ADDENDUM #1

PROJECT 2017-NC-002

Hugh Ice Loop Road Bridge Construction

Hugh Ice Loop Bridge		
DRAWN	DATE	Bridge Replacement
BTS	5/30/17	Bardstown, KY
APPROVED	DATE	Plan View
SCALE	SHEET	PROJECT NO.
1"=10'	4 of 6	2017-NC-002

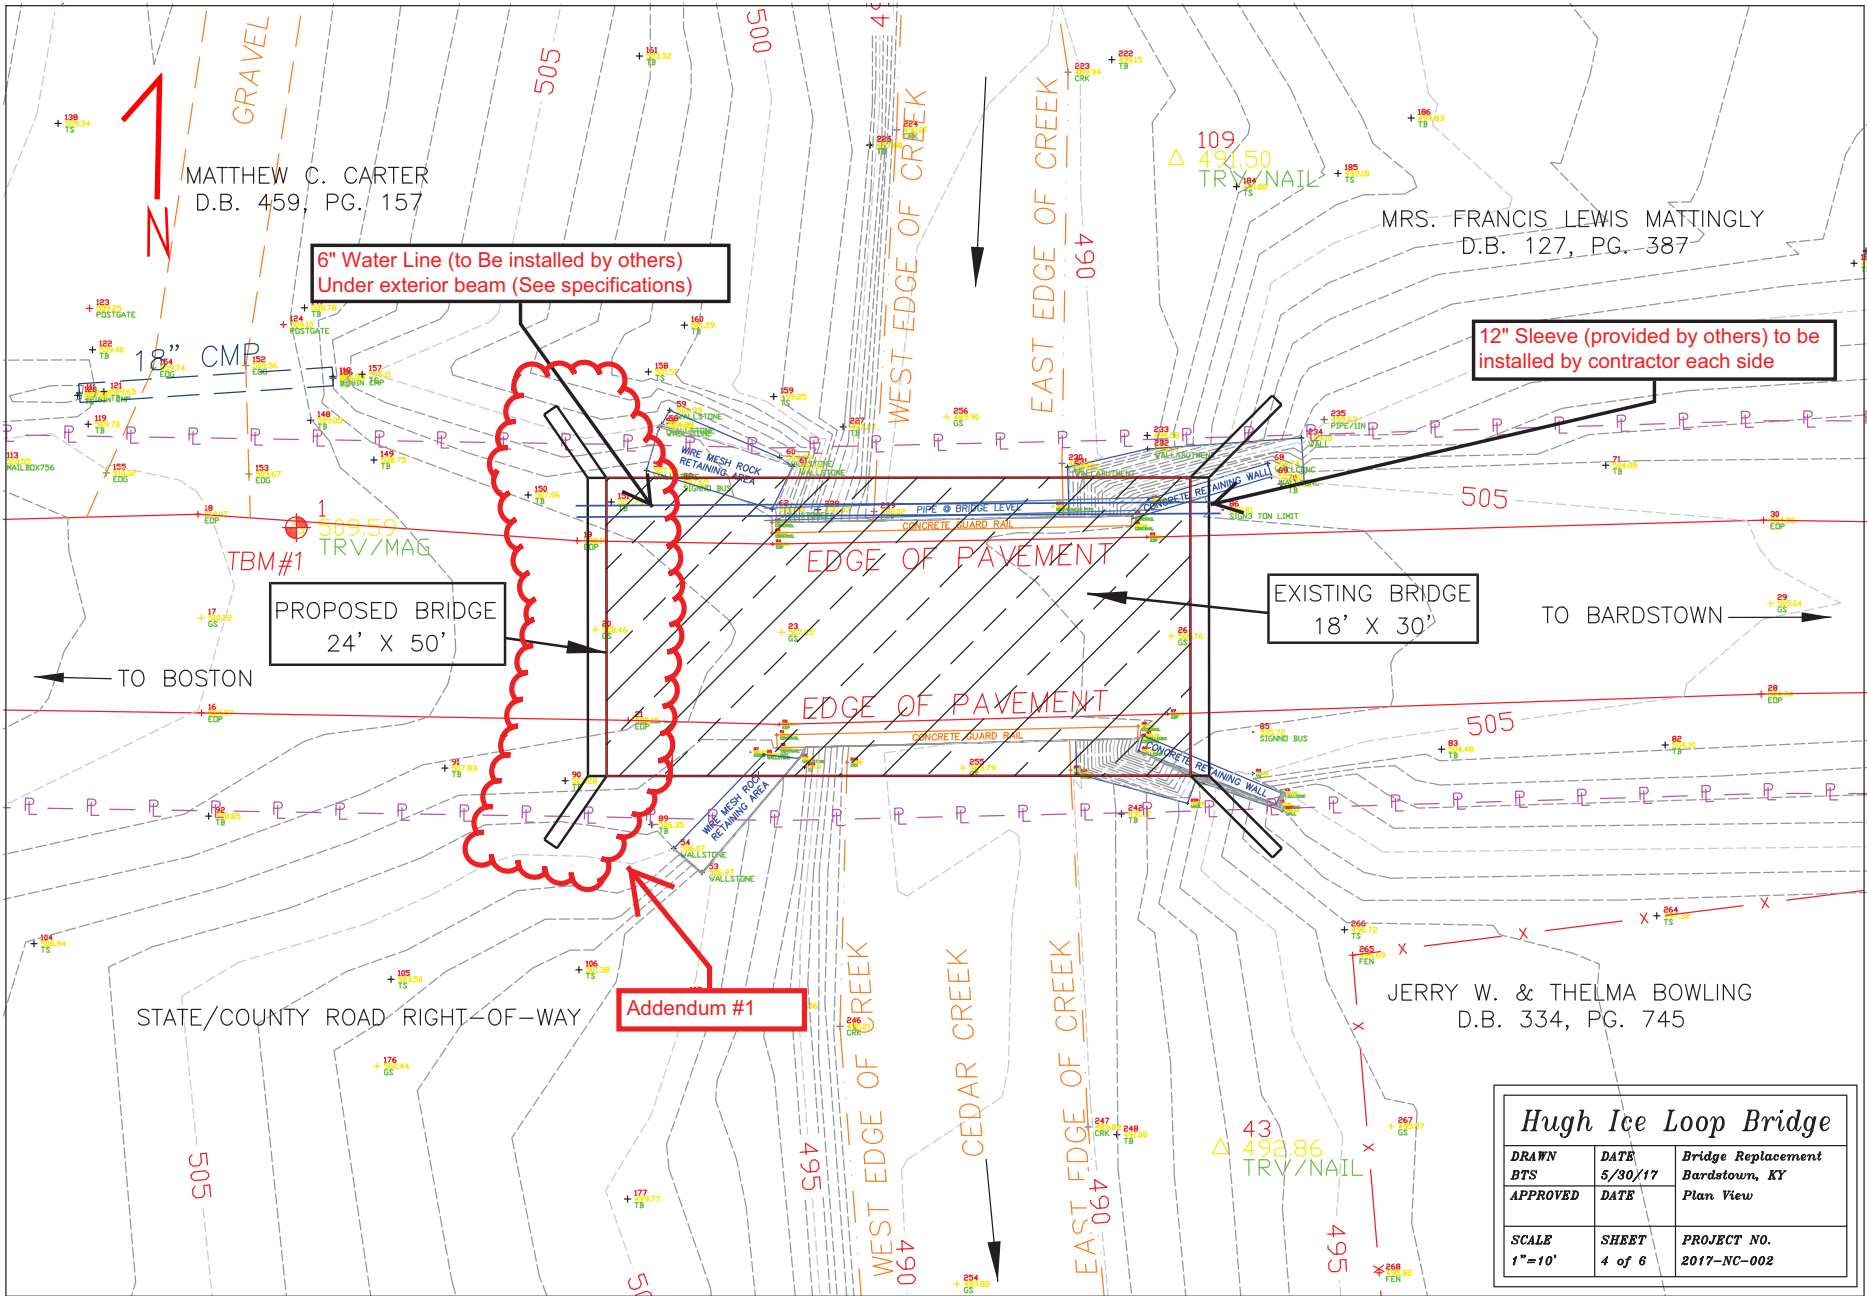
- 1.** The West Abutment shall be constructed per the Kentucky Department of Highways Standard Drawing # A-0024-02. The north wing-wall of this abutment shall be field skewed to ensure not to extend past the existing northern ditch line.
